Kansas Department of Agriculture
 Division of Water Resources
CHANGE: P/U WORKSHEET

DWR FIELD OFFICE APPLICATION FOR APPROVAL TO CHANGE THE PLACE OF USE AND/OR THE POINT OF DIVERSION

SUMMARY ORDER APPROVING APPLICATION FOR CHANGE AND IMPOSING CONDITIONS

RE: Water Right, File Nos. 15145, 15146
Place of Use Change Application

Change in Place of Use Map 24-26-15W // Pratt County

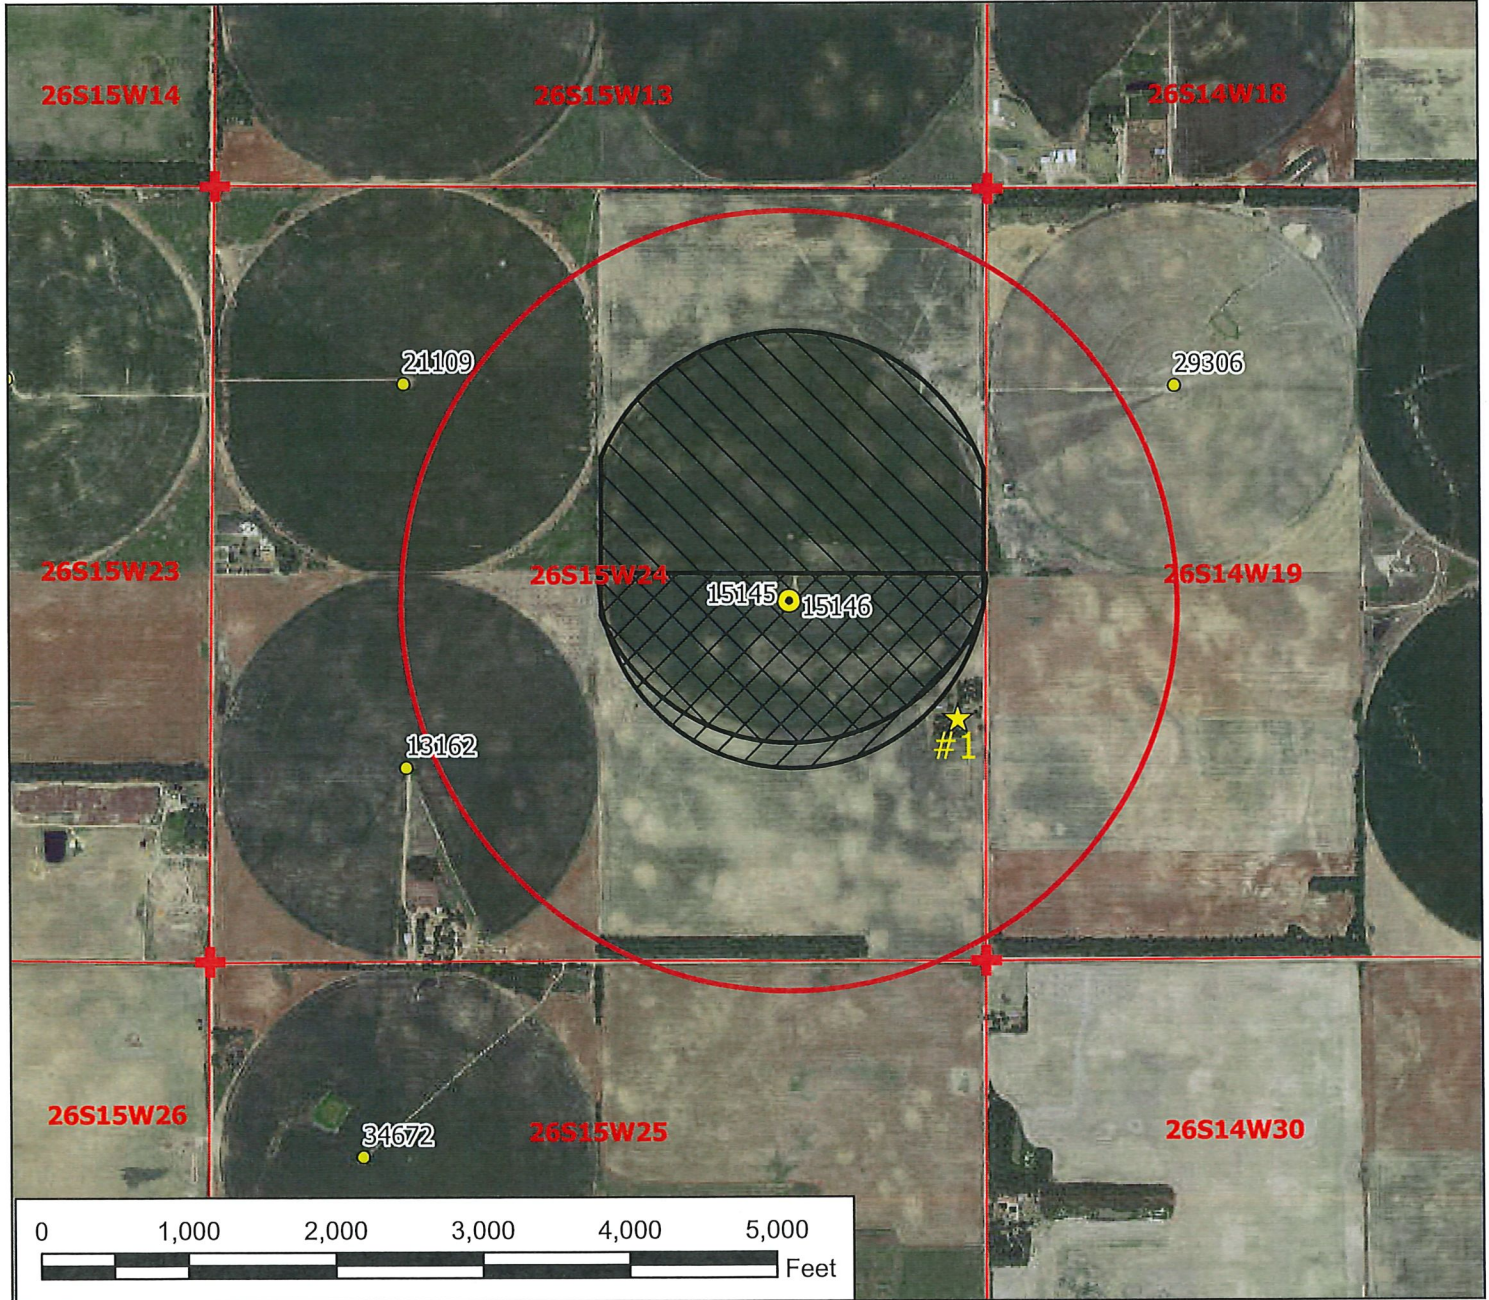
Sec.	Twp.	Range	NE¼				NW¼				SW¼				SE¼				TOTAL ACRES
			NE¼	NW¼	SW¼	SE¼	NE¼	NW¼	SW¼	SE¼	NE¼	NW¼	SW¼	SE¼	NE¼	NW¼	SW¼	SE¼	
24	26S	15W	5	5	37.5	37.5									26.25	26.25			137.5

7. The changes herein are desired for the following reasons?
 (please be specific) The place of use must be overlapped because the two water rights are currently both watering unauthorized acres as irrigated (15145 and 15146).
8. If a well, is the test hole log attached? Yes No
9. The change(s) (was)(will be) completed by?
ASAP
10. If the point of diversion is a well:
 (a) What are you going to do with the old well?
N/A
 (b) When will this be done? N/A
11. Groundwater Management District recommendation attached?
 Yes No
9/8/22 lpe
12. Assisted by TMA SFFO

This change needed to fix the place of use for the two files because there is presently a point of diversion overlap between the two, but they have separate places of use but both water the same pivot that is located in the East ½ of Sec. 24, Township 26 South, Range 15 West in Pratt County, KS. In addition, the pivot is not irrigating acres that are entirely authorized at present. The pivot is also larger than the 125 acres that is 69 acres + 56 acres combined. The pivot is actually 137.5 acres in total. Luckily, base acres for the two files turned out to be 137.5 acres exactly. This was determined through the 10% rule: 69 + 6.9 + 56 + 5.6 acres allowed. Thus, this change will comply with K.A.R. 5-5-11. The files will now both be authorized to pump to the entire pivot, not just one file per half of the pivot.

**Change in Place of Use Map
24-26-15W // Pratt County**

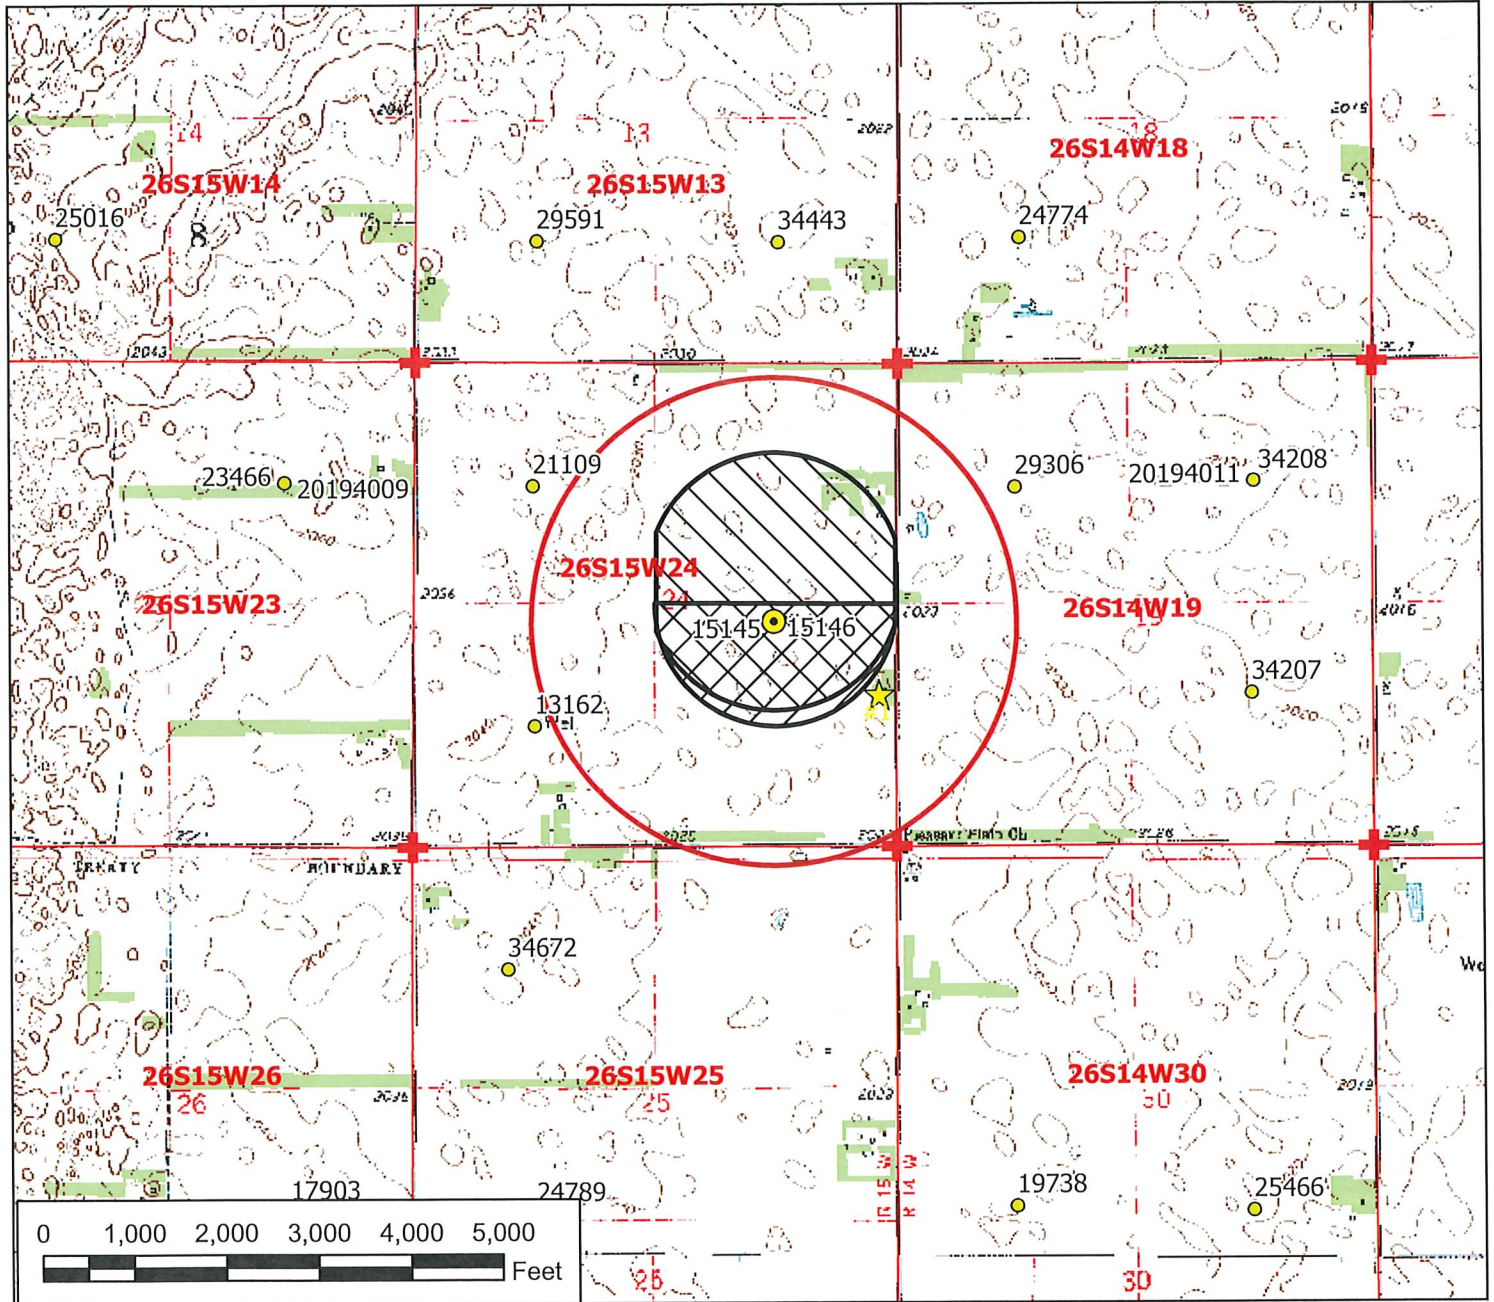
I have attached two change applications and a cover letter to this email. These changes create a place of use overlap for two files that have been an incomplete overlap. The PD is already overlapped and both files have individual quantities but different places of use authorized but water the same place of use. 15145 is authorized the South ½ of the pivot and then 15146 is authorized the North ½ . This means that 15145 is irrigating unauthorized acres in the North half of the pivot, while 15146 is irrigating unauthorized acres in the South half of the pivot. Additionally, the place of use is shifted north of what is authorized, so this change incorporates the extra acres covered by this shift as well. Base acre reviews were done on both files but their proposed certificates suggest base is 56 acres on 15146 and 69 acres on 15145. A change up to 137.5 acres is allowable per K.A.R 5-5-11 (69+6.9+56+5.6) and it just so happens that this is the correct size of the pivot as it is operating right now. This place of use is located in the NE and SE ¼ of 24-26S-15W in Pratt County.

Big Bend Groundwater Management District #5 has reviewed the above referenced application. The applicant is requesting to modify the place of use to create a complete overlap between these two water right files and to better represent how the system is currently configured. Based on information received in the office, the application appears to be consistent with 5-25-20(b) and is therefore recommended for approval.
